ADDENDUM NO. 03 to the plans and specifications for MACOMB COUNTY – COUNTY WAREHOUSE – F & O AND PURCHASING OFFICE RENOVATION, CLINTON TOWNSHIP, MI, Architect’s Project No. 242053, dated OCTOBER 31, 2024

Specification Sections: 01100, 07220, 08330, 08710, 10221, Revised Bid Form and Drawings G3.0, AD1.0, A1.0, A1.0A, A1.1, A1.2, A2.0, A3.0, A4.0, A4.1, A9.1, M1.10, M5.00, M6.00, E0.00, EP1.10, EL1.10 and E6.00 are being issued with this Addendum.

SUBJECT: RFB 29-24
QUESTIONS AND ANSWERS
MC WAREHOUSE – F&O AND PURCHASING RENOVATIONS

MECHANICAL NEW WORK FIRST FLOOR PLAN
SCALE: 1/8" = 1'-0"

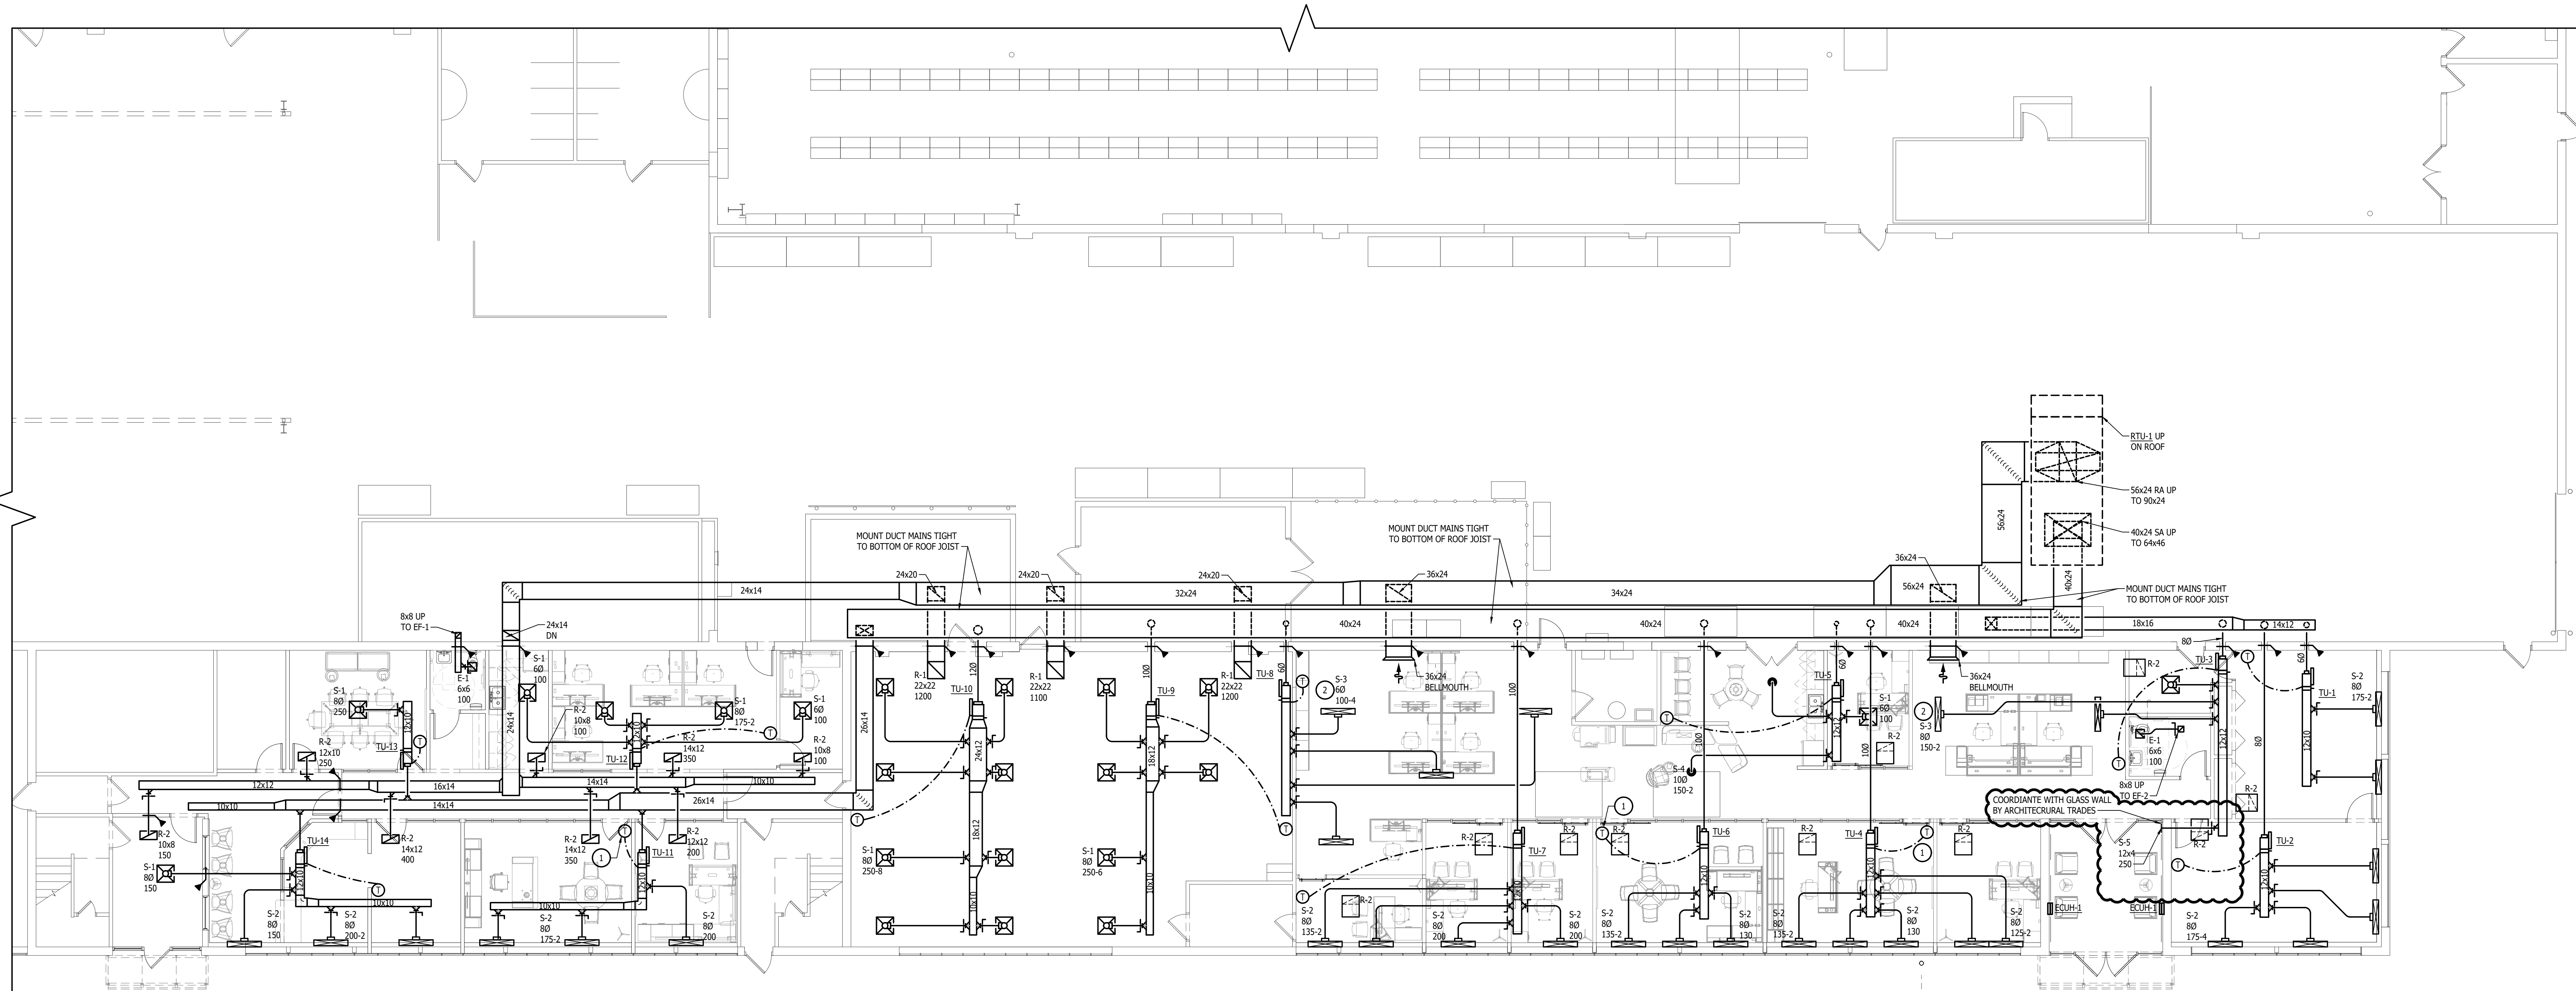
- ITEM NO. M1:** Refer to sheet M1.10 Mechanical New Work First Floor Plan (Re-issued);
1. Adjusted layout of diffusers in vestibule. Added note to coordinate with architectural wall.
- ITEM NO. M2:** Refer to sheet M5.00 Mechanical Details (Re-issued);
1. Added roof curb capping detail.
- ITEM NO. M3:** Refer to sheet M6.00 Mechanical Schedules (Re-issued);
1. Adjusted Sk-1 model numbers
2. Adjusted airflows and discharge air temperature for tu-3
3. Added S-5

ELECTRICAL POWER NEW WORK FIRST FLOOR PLAN
SCALE: 1/8" = 1'-0"

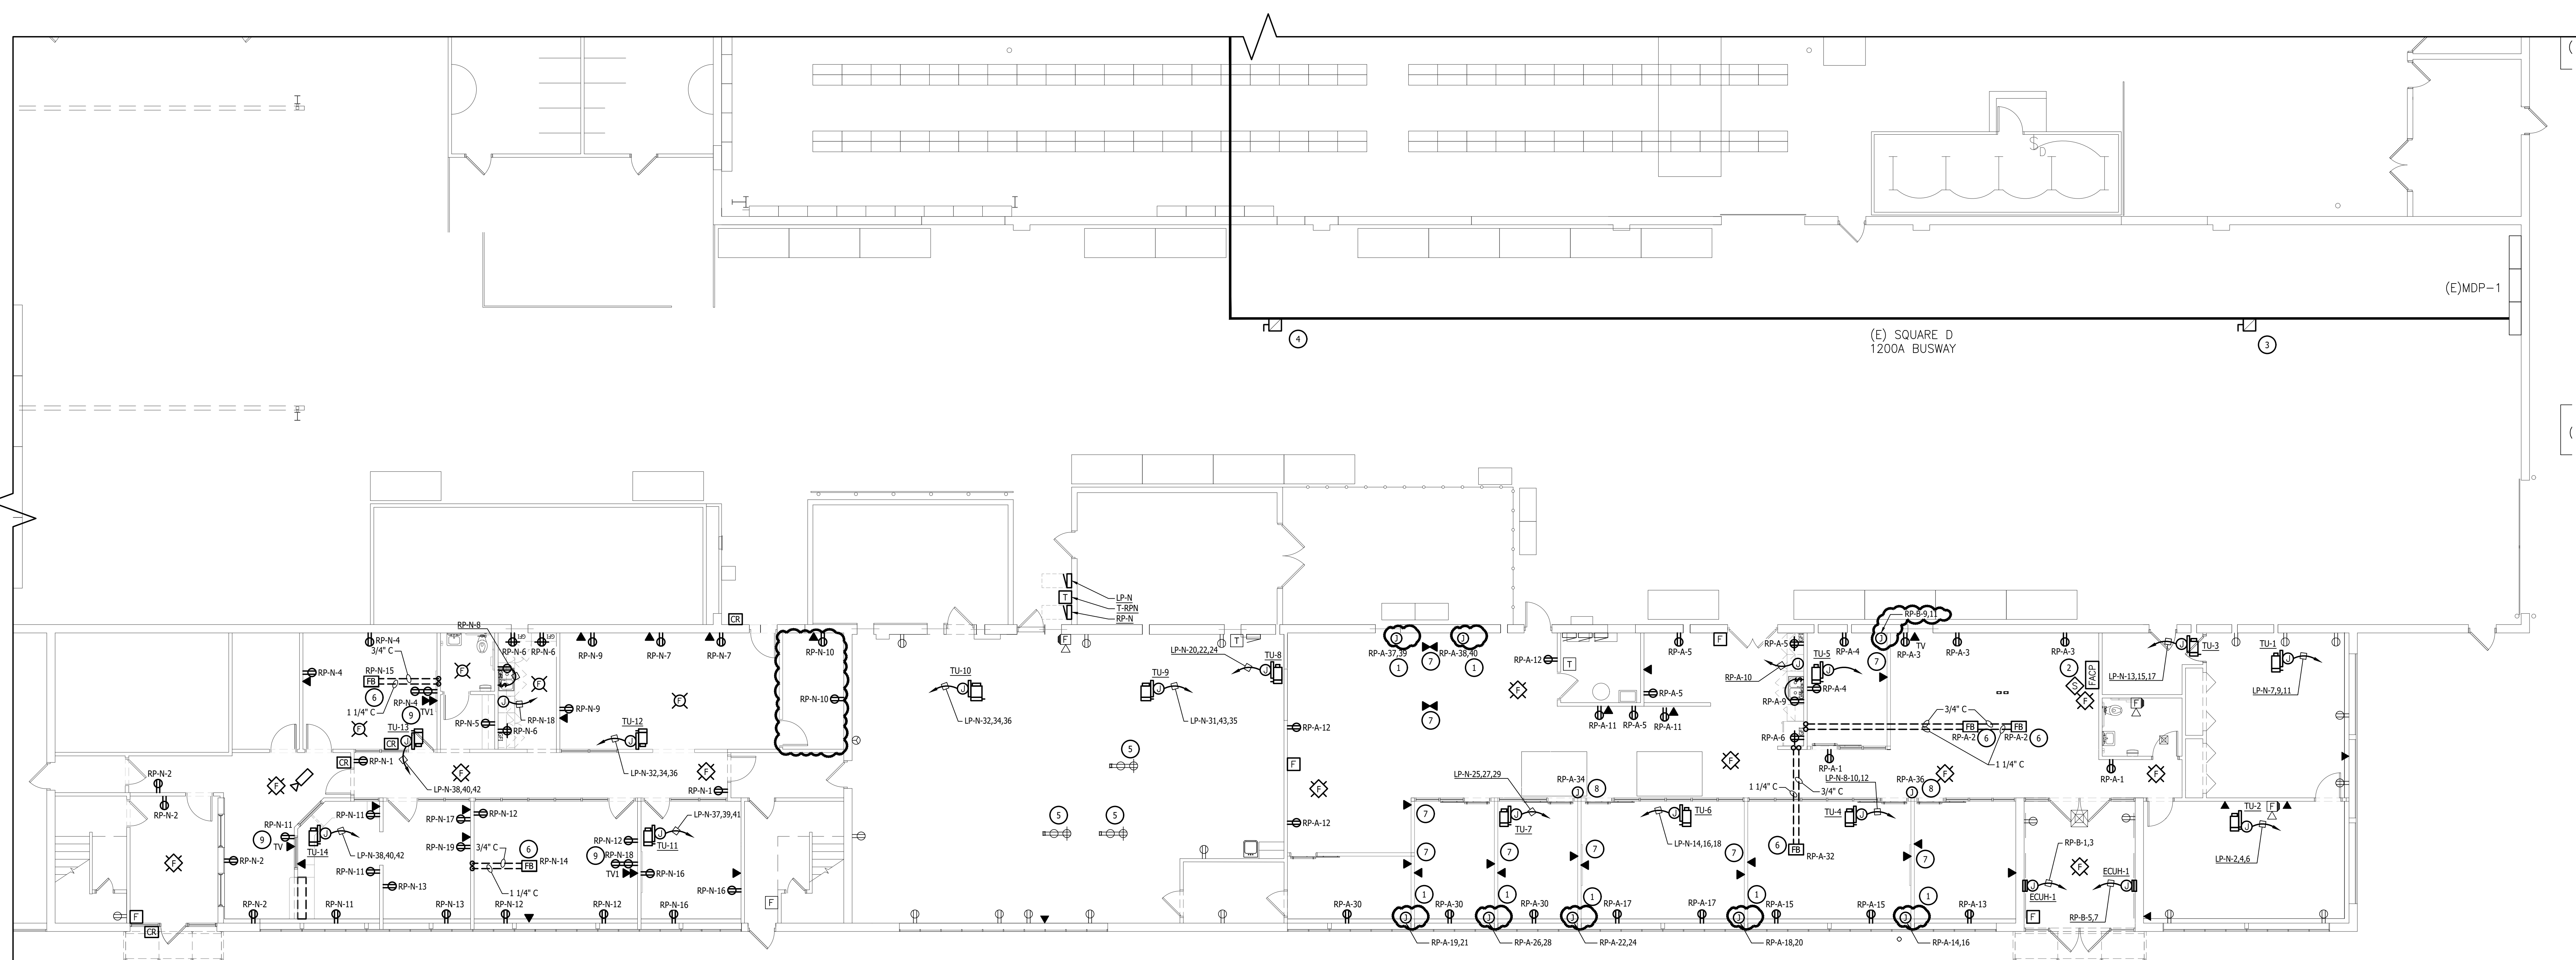
- ITEM NO. E1:** Refer to sheet E0.00 Electrical General Information and Lighting Schedule (Re-issued);
1. Modified Fixture G to "Damp Rated".
2. Modified Fixture X.
3. Removed Fixture X1.
4. Modified Fixture X2.
- ITEM NO. E2:** Refer to sheet EP1.10 Electrical Power New Work First Floor Plan (Re-issued);
1. Removed data junction boxes as indicated on plans.
2. Added junction box for power for demountable wall as indicated on plans.
3. Adjusted power for small offices in purchasing as indicated on plans.
4. Modified keynote #1.
5. Modified keynote #7.

ELECTRICAL LIGHTING NEW WORK FIRST FLOOR PLAN
SCALE: 1/8" = 1'-0"

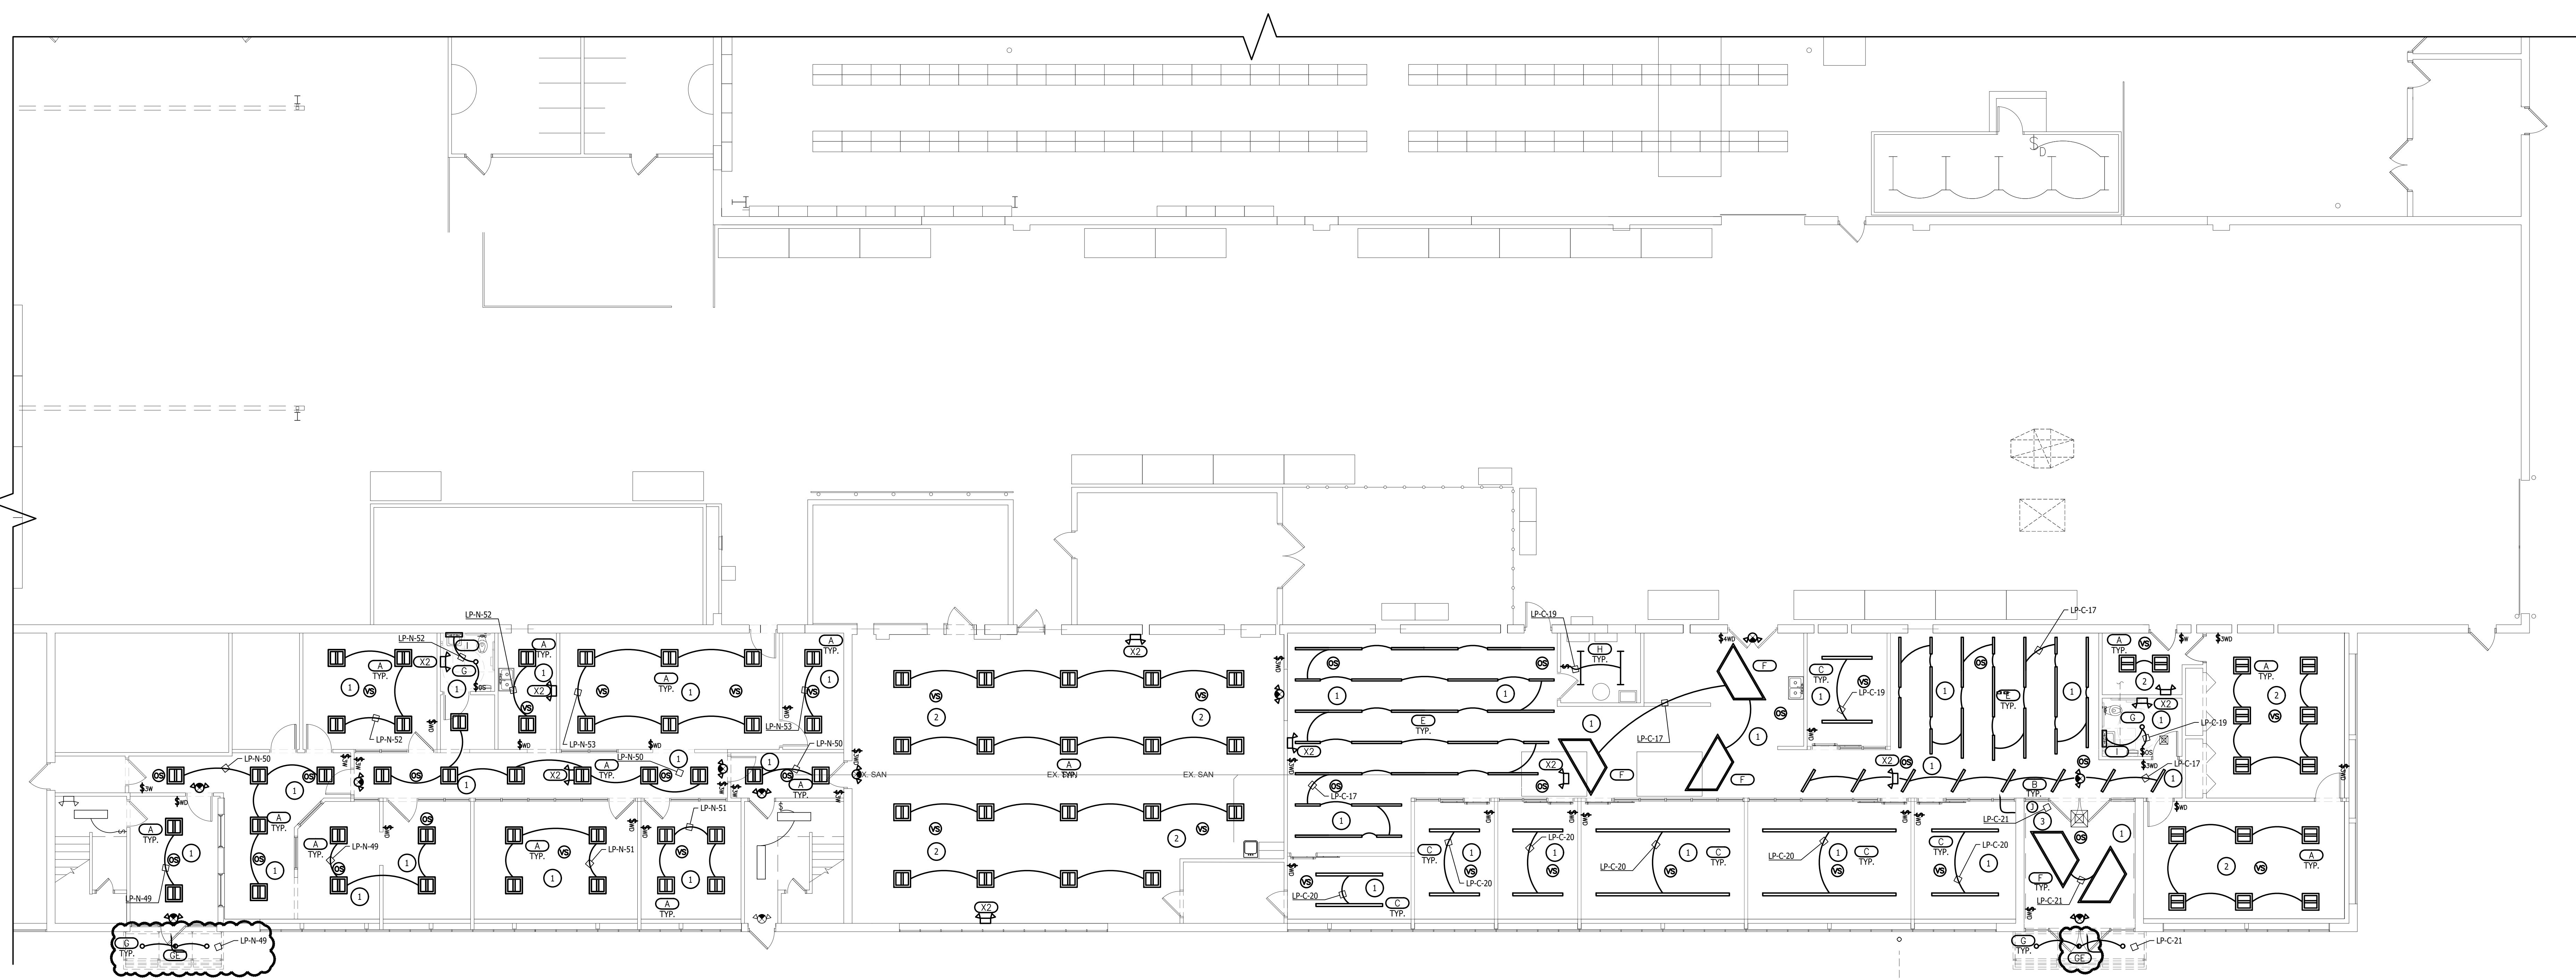
ITEM NO. E3: Refer to sheet EL1.10 Electrical Lighting New Work First Floor Plan (Re-issued);
1. Added EM (Fixture GE) to F/O entrance as indicated on plans.
2. Added downlights to purchasing entrance as indicated on plans.
